**Response to RAIs on WCAP-17788**  
**Volume 4 - B&W Plants**

ANP-3584NP

LICENSING REPORT

Revision 1

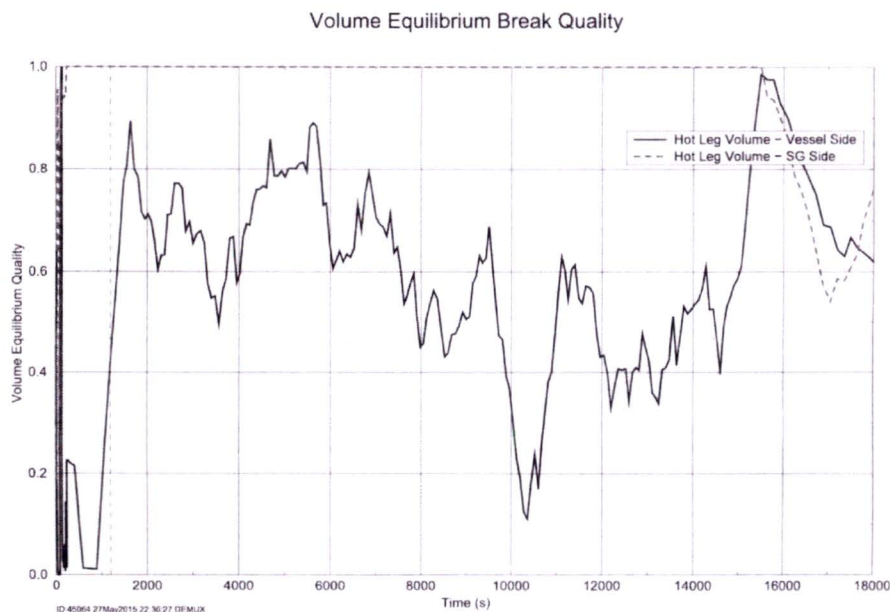
- (iv) Predicted pressure difference between the upper plenum cell connected to the broken hot leg pipe and the containment backpressure.
- (f) Figure 1 below compares predicted exit qualities for the original analysis of Case 1 used to determine  $t_{\text{block}}$  for the CE plant category as documented in Section 10 and the revised analysis in Erratum, submitted with the February 12, 2016, letter OG-16-42 ( $t_{\text{block}}=20,000$  seconds). It is noted that the results are significantly different following the simulated blockage time in each analysis. The results also differ during some time periods prior to 15,000 seconds, which is the earlier of both simulated  $t_{\text{block}}$  times. Describe why the results prior to 15,000 seconds are not consistent between the two cases and state which case presents the correct values. Provide similar information for the time period after blockage is simulated. Please describe why the results fluctuate significantly and justify that the code performance provides a valid representation of the system.

- (h) Investigate whether the substantial scatter in the  $m_{\text{split}}$  results shown in Figure 10-5 is related to the behavior of the break liquid carry-out result. Note that if the liquid carryover is incorrect, it can render the  $m_{\text{split}}$  result unacceptable. Describe whether correction of the  $m_{\text{split}}$  results was found necessary to address the observed scatter
